FCC Class II Permissive Change Request Letter

RE: FCC Permissive II Change Request for Company: Soundlab Technology Company Limited FCC ID: 2ATKO-BAR600II

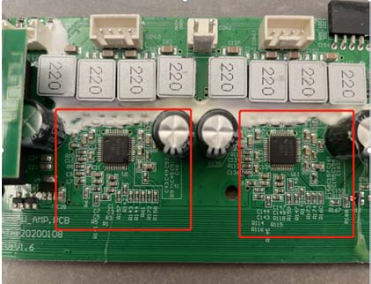
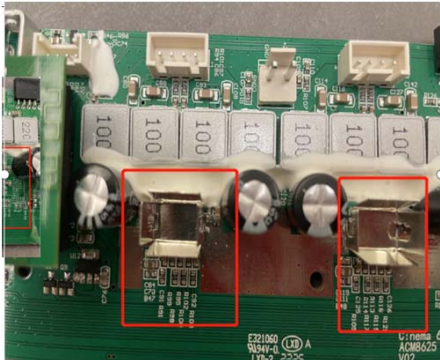
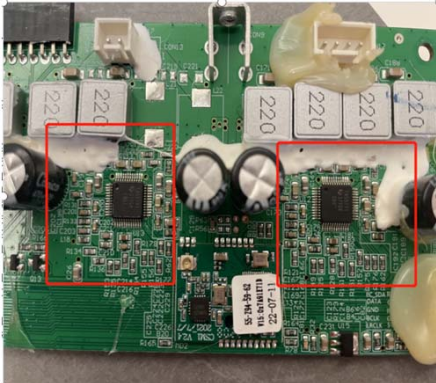
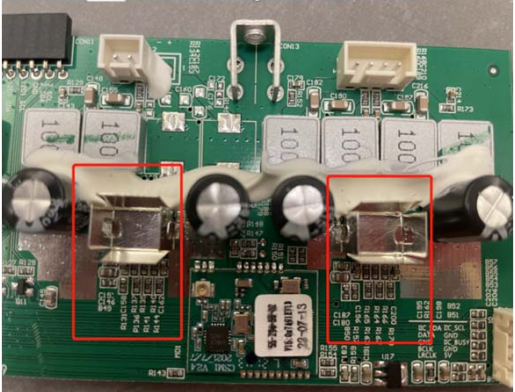
power supply board, audio amplifier IC and peripheral circuit were changed and add model number. See the appendix

Change description	original mainboard	new mainboard
<p>delete</p> <p>R12, R16, R14, R19, R10, R8, R6, R5, R141, R3, R1, R157, R142, R143, R144, R61, R172, R158, R119, R120, R112, R11, R13, R114, R116, R145, R118, R115, R159, R147, R146, R148, R173, R174, R160, R167, R168, C31, C55, C29, C25, C27, C57, C21, C23, C19, C13, C23, C15, C11, C9, C7, C5, C1, C3, C43, C49, C53, C41, C45, C51, C48, C138, C148, C153, C151, C1</p> <p>add</p> <p>C87, C95, C105, C82, C77, C99, C83, C85, C84, C78, C91, C92, C120, C117, C116, C122, C139, C138, C129, C119, C111, C126</p> <p>R91, R99, R98, R95, R100, R102, R103, R109, R114, R117, R113, R119, R118, R121.</p>		
<p>delete</p> <p>C205, C215, C2183, C220, C218, C209, C199, C200, C201, C203, C202, C211, C206, C207, C198, C210, C26, C214, C216, C225, C226, C224, C222, C229, C228, C223, C125, C172, C182, C180, C187, C185, C195, C190, C196, C176, C165, C174, C164, C173, C167, C169, C177, C168, C166, C178, C181, C183, C192, C191, C193, C189</p> <p>R137, R139, R140, R132, R131, R133, R134, R136, R135, R153, R138, R57, R154, R178, R155, R156, R165, R177, R62, R63, R56, R127, R129, R130, R122, R103, R180, R121, R123, R124, R126, R149, R125, R128, R161, R151, R152, R175, R176, R162, R150.</p> <p>add</p> <p>C152, C154, C150, C171, C163, C157, C170, C164, C177, C151, C146, C158, C162, C188, C185, C184, C194, C201, C213, C212, C204, C187, C180, C196, C200</p> <p>R148, R147, R131, R137, R136, R135, R141, R140, R144, R150, R151, R163, R165, R157, R166</p>

<p>delete U1, U11, U13, U12 (IC MODE:TAS5731)</p> <p>add: U13, U14, U15, U16 (IC MODE:ACM8625)</p>
